## Design Review Board

March 22, 2017

<b>NAME OF PROJECT:</b>	
Spokane Falls Combined Sewer Overflow (CSO 26) Control Facility - PLAZA	
<b>ADDRESS:</b>	
218 N. Monroe Street	
<b>TYPE OF PROJECT:</b>	
<input checked="" type="checkbox"/> Public Project <input type="checkbox"/> Shoreline Conditional Use Permit <input type="checkbox"/> Skywalk Over Public ROW	<input type="checkbox"/> Required by CBD Zones and Downtown Plan <input type="checkbox"/> Design Departure
<b>FEES:</b>	
Standard Board Review Paid for by Interfund Charge - Utilities	
<input type="checkbox"/> \$1275 (up to 3 meetings)	<input type="checkbox"/> \$500 per additional meeting if necessary

## 1 Retail-A South Elevation (Presented at Collaborative Workshop) SCALE: 1" = 40'-0"

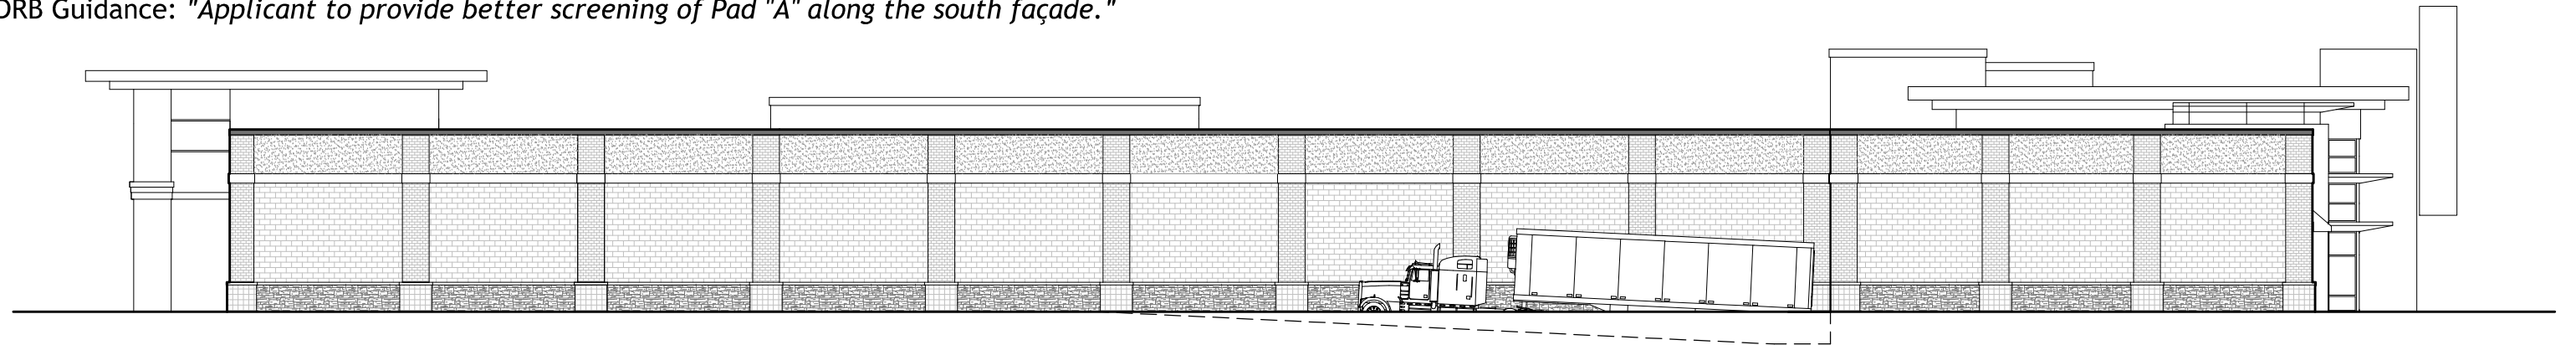
DRB Guidance: "Applicant to provide better screening of Pad "A" along the south façade."

In addition to incorporating Ponderosa Pine into select areas of the landscape buffer screen, the south facade' has been enhance with vegetative screen walls located between the Retail-A service area and the property line. Parapet articulation and changes in materials and textures are also used to reduce mass and visual impact.
